AI/230817 / LLFA Letter / SCP Response  
24 February 2025

Planning Reference – 139751/FO/2024

**SCP Technical Response to Manchester City Council Planning Condition [PC27] Drainage**

PROPOSED CATCHMENT AREAS

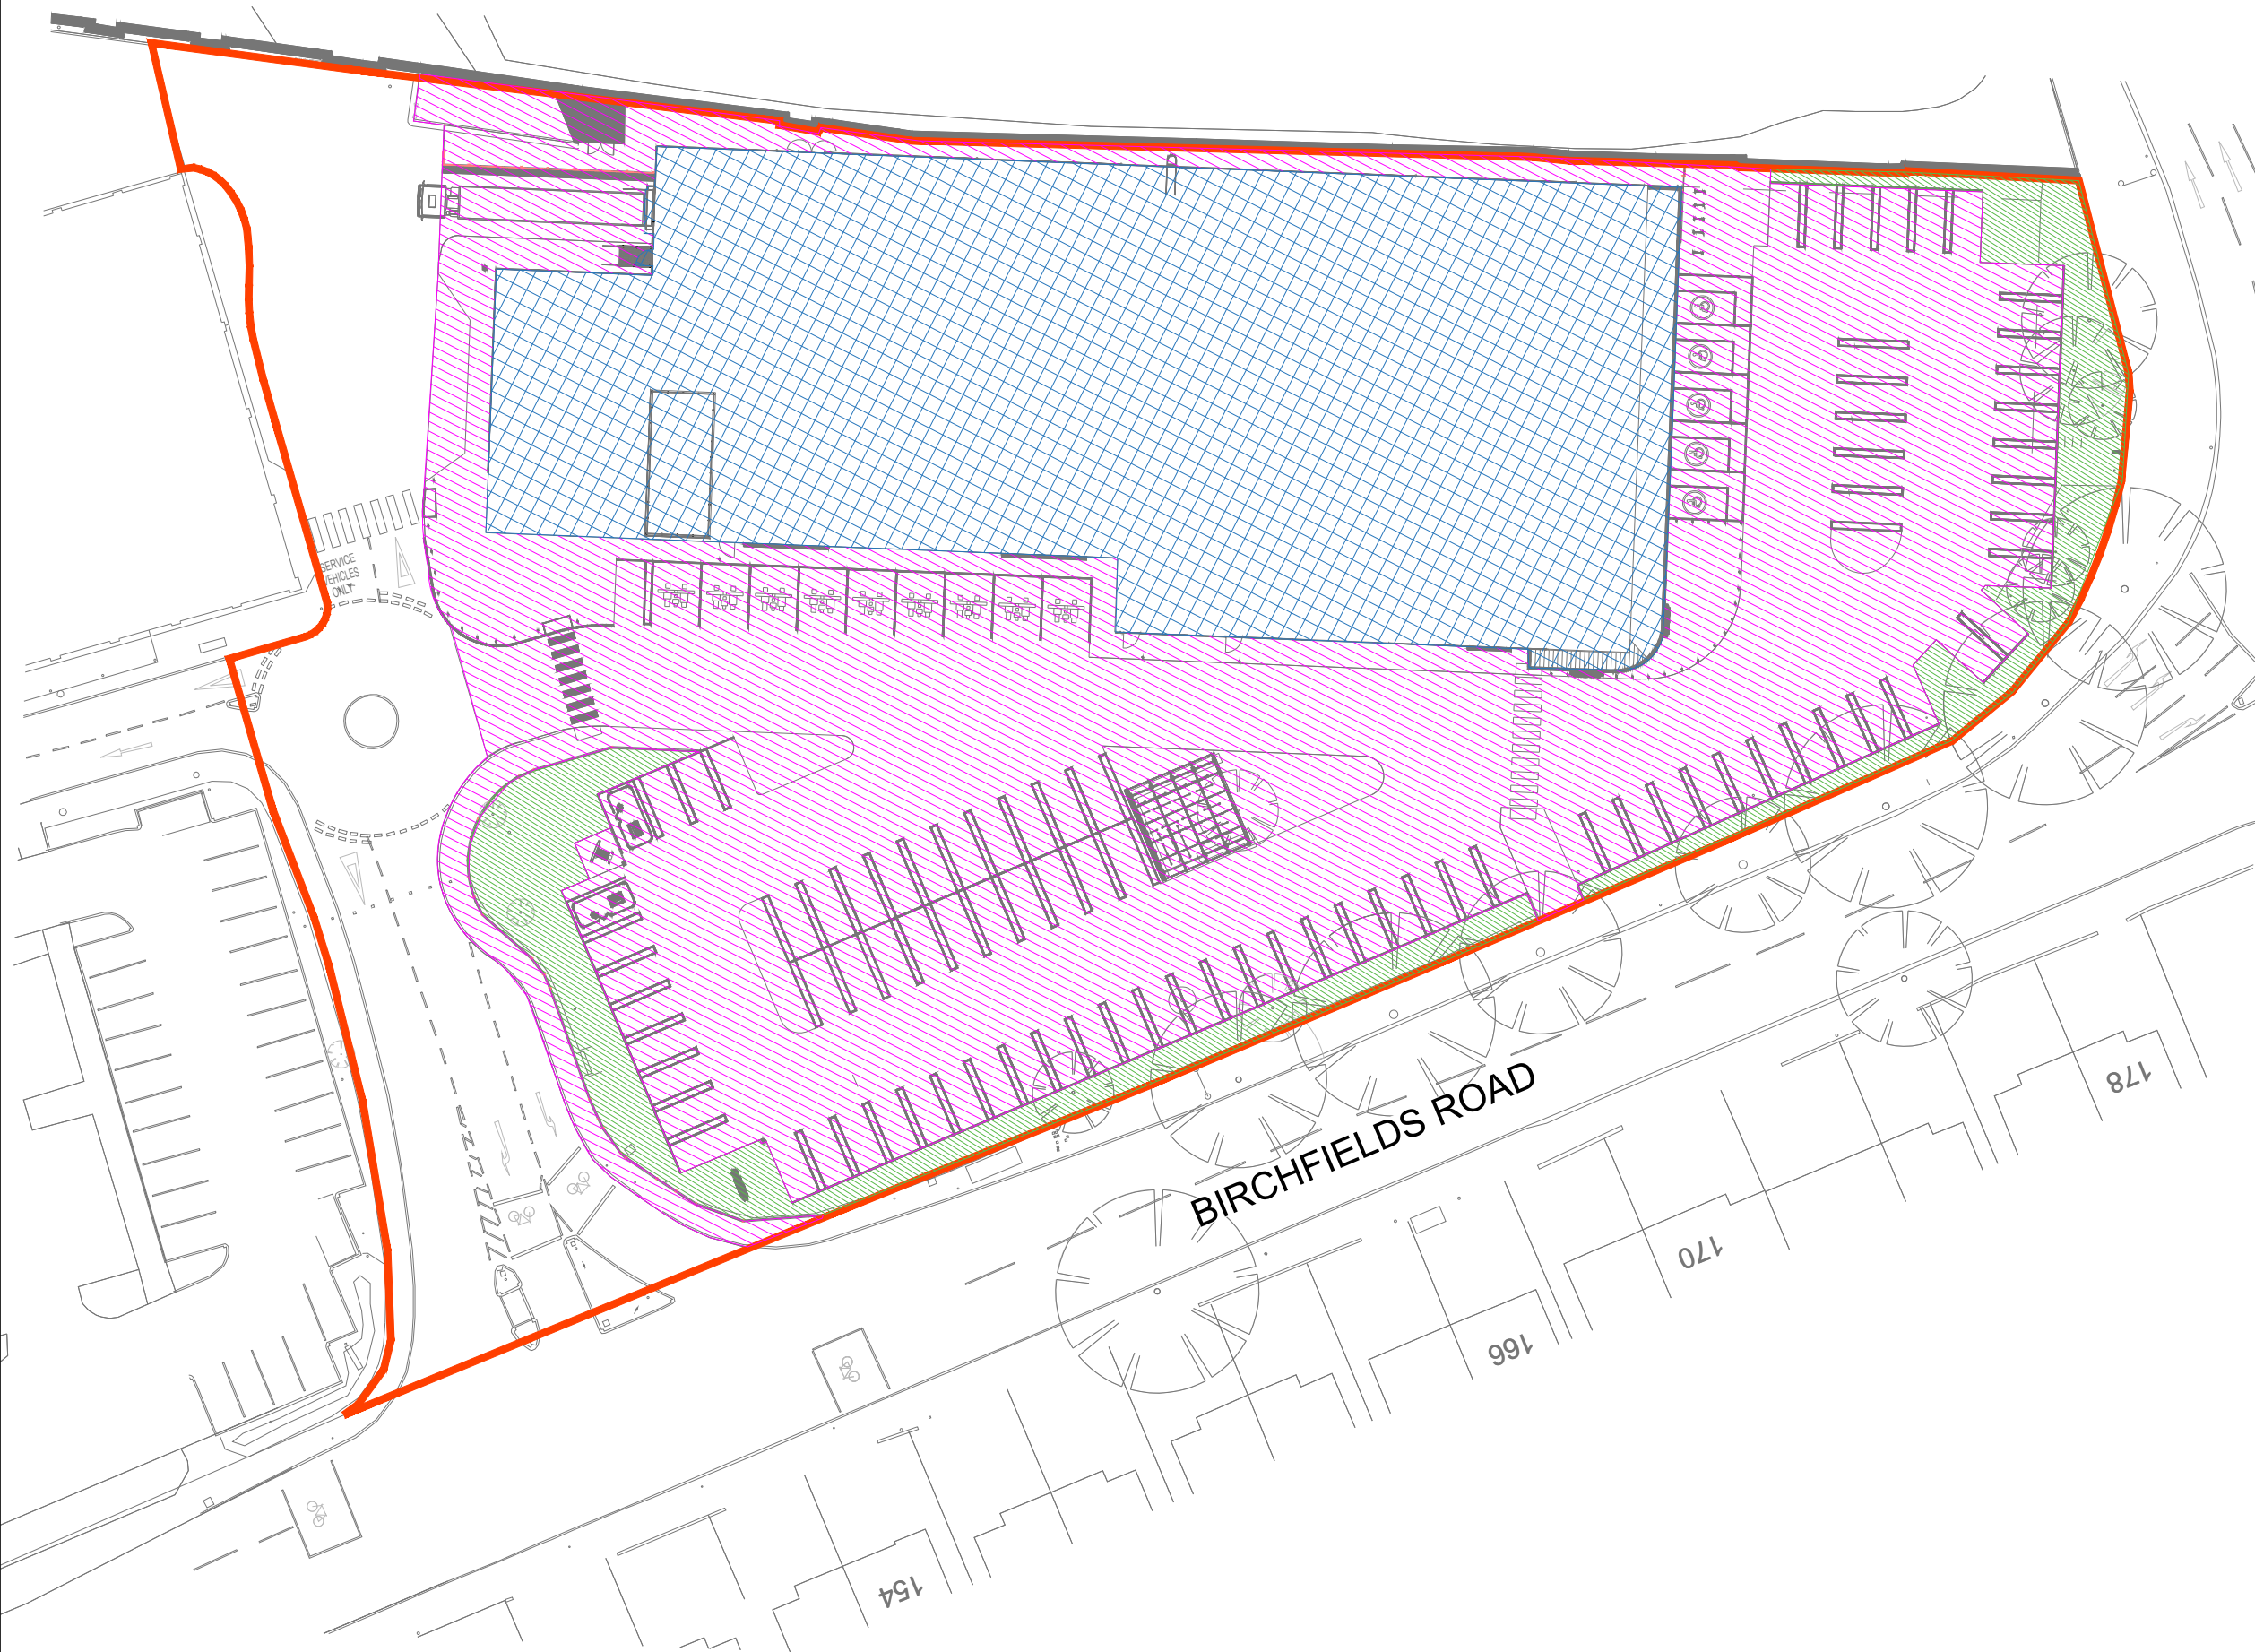
| Number | Item                                                                                                                                                                                                                                                                                                                                                                                                                                                                   | Response                                                                                                                                                                                                                                                                                                                                                                                                                                                                                                                                                                                                               |
|--------|------------------------------------------------------------------------------------------------------------------------------------------------------------------------------------------------------------------------------------------------------------------------------------------------------------------------------------------------------------------------------------------------------------------------------------------------------------------------|------------------------------------------------------------------------------------------------------------------------------------------------------------------------------------------------------------------------------------------------------------------------------------------------------------------------------------------------------------------------------------------------------------------------------------------------------------------------------------------------------------------------------------------------------------------------------------------------------------------------|
| 4      | An <b>existing and proposed impermeable areas drawings</b> to accompany all discharge rate calculations                                                                                                                                                                                                                                                                                                                                                                | <p>Refer to the <u>planning approved</u> Flood Risk Assessment revision G – Appendices B and C.</p> <p>Refer to existing and proposed impermeable area plans which can be found in <b>Appendix D</b> of this report</p>                                                                                                                                                                                                                                                                                                                                                                                                |
